# PCN# 20141212001 CC102x/CC1150 Orderable Part Number Retirement and Replacement

**PCN Number:** 20141212001 **PCN Date:** 12/16/2014

Title: CC102x/CC1150 Orderable Part Number Retirement and Replacement

**Change Type:** Orderable Part Number Retirement and Replacement

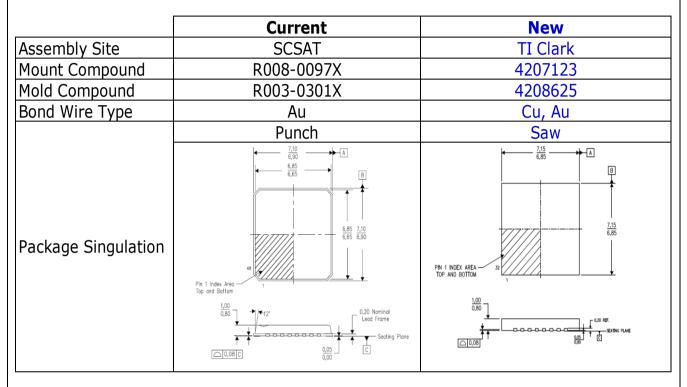
Note that the replacement product packages are sawn cingulated and are considered backwards compatible with the current punched packages, i.e. no PCB footprint change is necessary. Packing materials (shipping boxes, tape & reels, etc.) at the additional site will be consistent with materials currently in use at the current site.

Note also that the material sets of the replacement products are changing per the below:
